SERVICE NOTE

400D-4B

Ⓢ MODEL 400D/H VACUUM TUBE VOLTMETERS
 400D serial 17970 and below, 400H serial 2237 and below
 REDUCTION OF RESIDUAL NOISE MODIFICATION KIT
 Ⓢ STOCK NO. 400D-95B

Figure 1. Input Resistor Board Before Modification

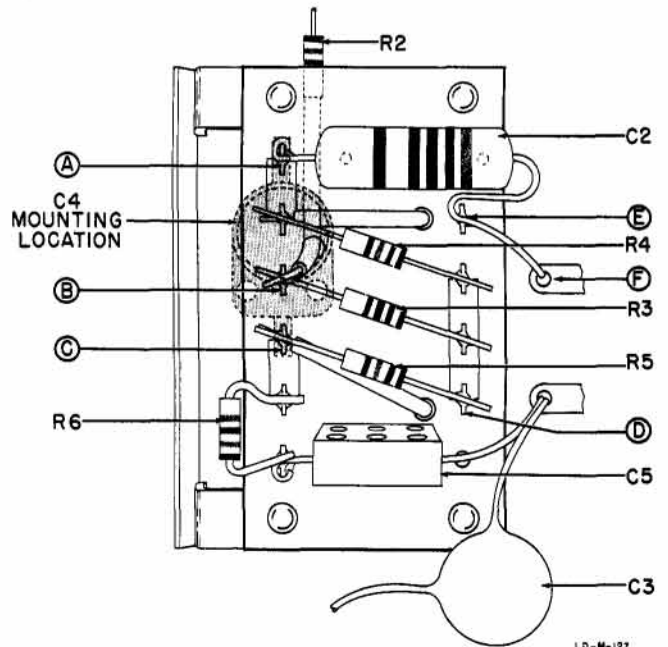
- 1) Remove the input attenuator resistor board shield. In 400H instruments, a small shield mounted below the power switch must also be removed.
- 2) Disconnect and save the variable ceramic trimmer (C4) connected between terminals A and C of the resistor board. Refer to figure 1. This variable capacitor for C4 will be replaced before the modification is completed.

- 3) Disconnect the end of the 0.01 μ f disc capacitor for C3 to gain access to the resistors under C3.
- 4) Remove and discard resistors R3, R4, and R5.

- 5) Replace resistor R2 with a 100 ohm, $\pm 10\%$, 1/2 watt resistor. Keep resistor lead lengths the same and reuse the sleeving and rubber grommet from the old resistor.

- 6) Mount the resistors supplied in the Ⓢ Stock No. 400D-67 Matched Resistor Set in the 400D-95B Modification Kit. The resistors in this matched set must not be overheated or scratched during installation.

9) Resistor R6 is composed of three 10%, 1/2 watt, composition resistors connected in parallel and mounted as shown in figure 1. There should be two 10 ohm resistors and one 27 ohm resistor. Use the resistors supplied in the modification kit to replace any or all resistors for R6 that do not have this value.

MAKE VOLTMETER SCHEMATIC DIAGRAM AGREE
WITH THE FOLLOWING PARTIAL DIAGRAM

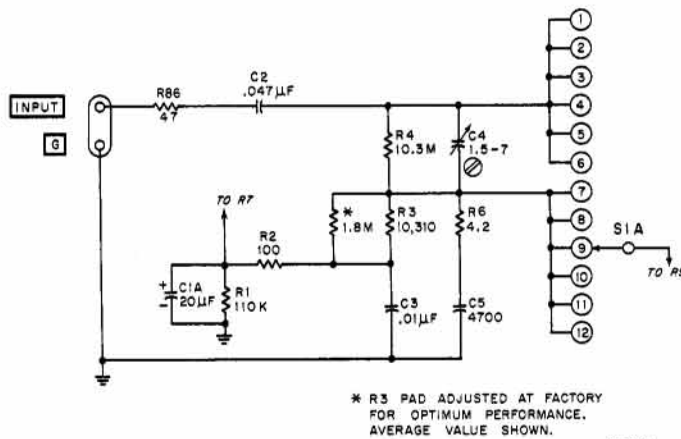
The 1000:1 input voltage divider which is switched into the input circuit for the one-volt range and above, has been changed from a capacitive to a resistive type divider. The 1000:1 voltage division is now determined at audio frequencies mainly by factory matched resistors R3 and R4 and very slightly by C4 which flattens the response of the 1000:1 divider at higher frequencies.

C4 also affects the calibration of the one-volt range and above even at low audio frequencies i.e.: 400 cps. The calibration process now becomes a part of the frequency-compensation adjustment process. Trimmer C4 has been properly set at the factory and should never need adjustment. If C4 is accidentally disturbed the accuracy of the meter will be destroyed except at very low audio frequencies.
